SERVICE BULLETIN

No. 733

Piper Aircraft Corporation

Emergency Exit Window Installation

SKETCH "A"

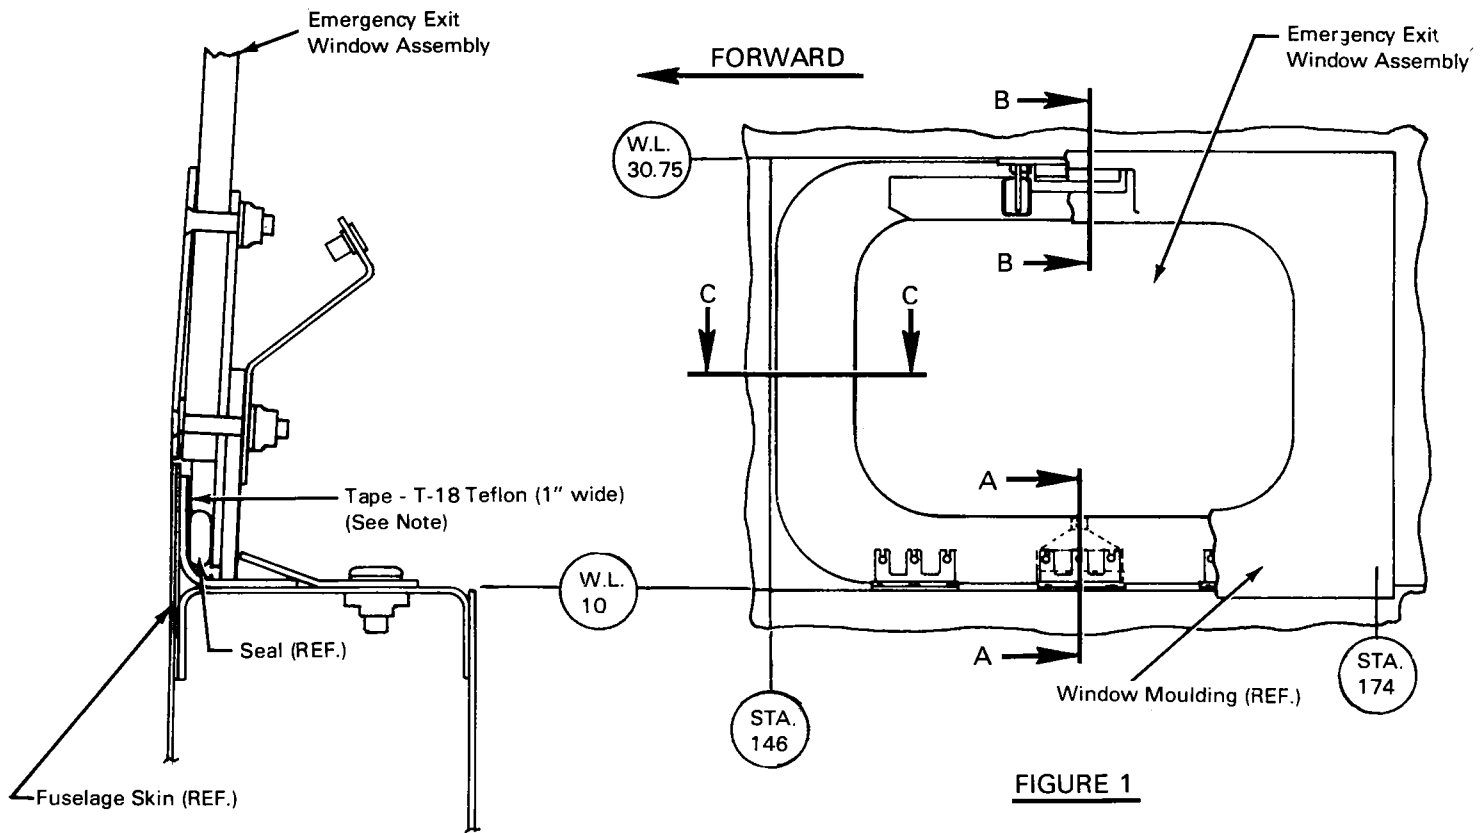
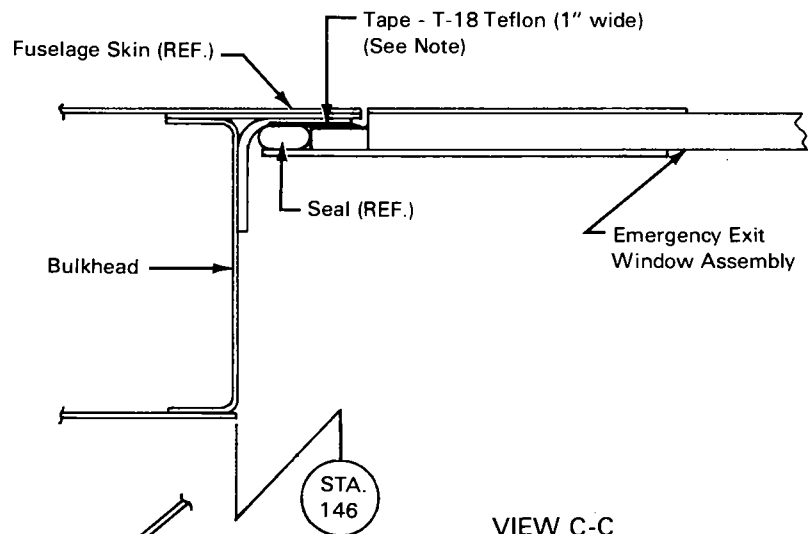
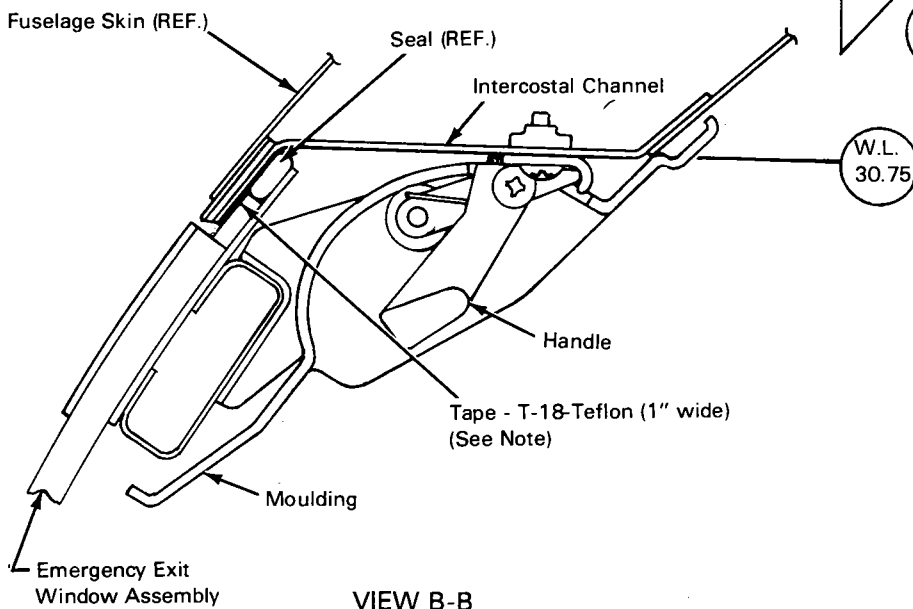
Purpose: In the above-listed aircraft the emergency exit window could stick in the fuselage frame, requiring greater than acceptable force for removal. This could cause difficulty in an emergency situation.

1. Remove the emergency exit window.
2. With Methyl Ethyl Ketone, clean the fuselage frame in the area of the fuselage to remove excess fuselage sealant.
3. Refer to attached sketch. Install 1 inch wide Teflon Tape around the sill as shown. Make sure the surface of the tape is clean.
4. Reinstall the window assembly. Remove and reinstall to insure proper operation.
5. Make appropriate logbook entry of compliance with this Service Release.

NOTE: The T-18 Teflon Tape Must Adhere To The Fuselage Window Frame Prior To Installing The Emergency Exit Window Assembly.
